# **Brown Creek Tributaries Restoration Project FINAL Year 7 Monitoring Report/Closeout Report**

DMS Project ID No. 95351  
DEQ Contract No. 004641  
USACE Action ID: SAW-2012-01108  
DWR Project #14-0345  
RFP #16-004108 (Issued 6/20/2011)  
Yadkin River Basin: 03040104-061030

**Subject:** Response to DMS Comments for Task 13 Deliverables: Year 7 Monitoring Report  
Brown Creek Tributaries Restoration Project, Anson County, Yadkin River Basin – CU# 03040104,  
DEQ Contract No. 004641, USACE AID SAW-2012-01108, DMS Project #95351

Figure 2E  
Current Condition Plan View  
Monitoring Year 7  
Brown Creek Tribs: UT4 Site

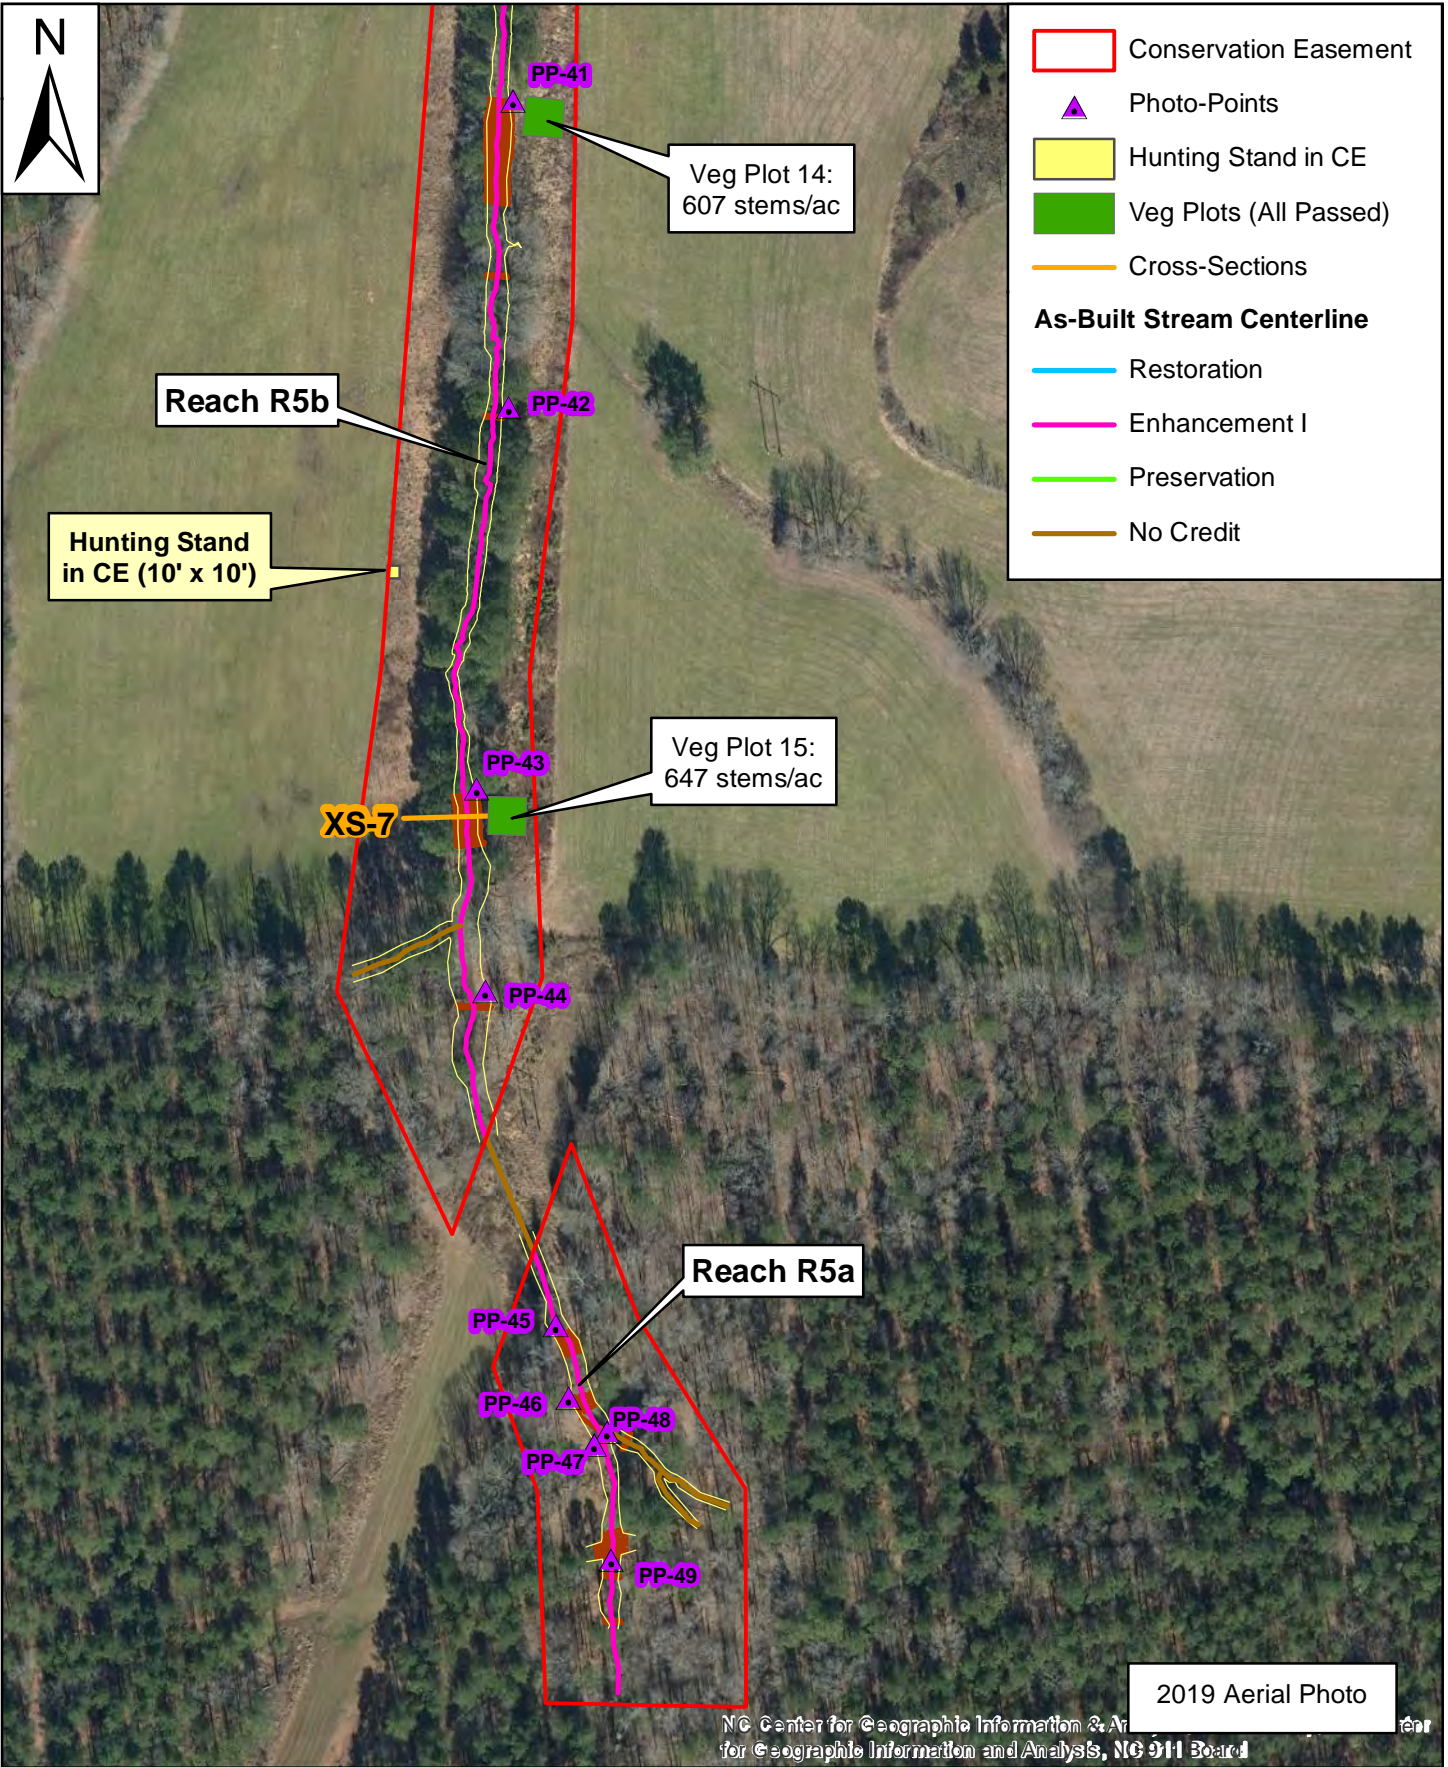
- Figure 2D: Thank you for adding the callout to show the area of pine harvesting within the easement.  
**Response: We appreciate the positive feedback.**
